REF: 23/00853/OUT**Location: Land East Of Warwick Road Drayton Warwick
Road Banbury****18 May 2023**

Comments on outline plans provided

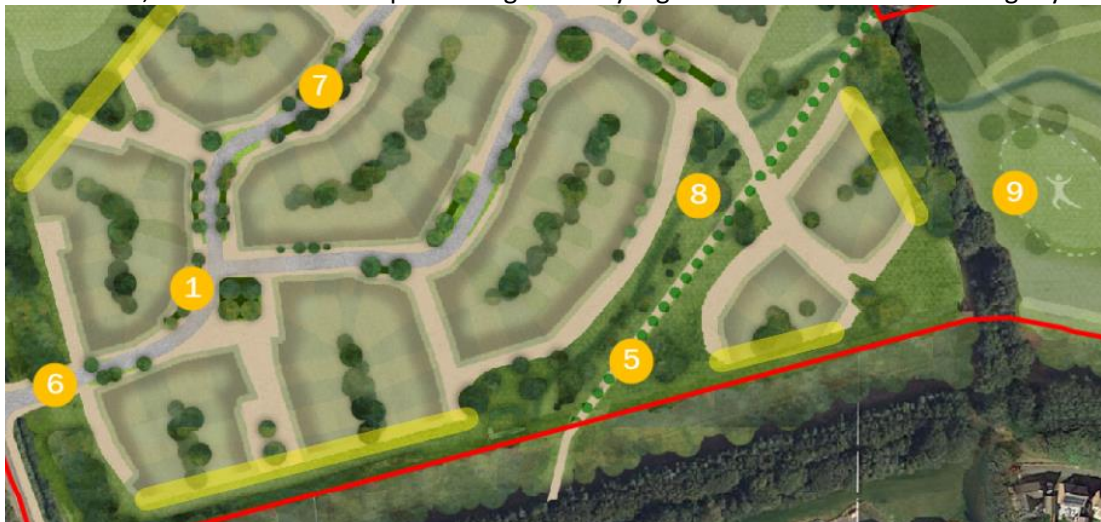
- Where blocks are adjacent to areas of green space such as in the areas highlighted yellow below, it is imperative that building frontages/orientations, landscaping and boundaries clearly demonstrate that vulnerable side/rear garden boundaries are not exposed and unprotected in areas devoid of surveillance, as this would leave plots at significantly higher risk of crime such as burglary.
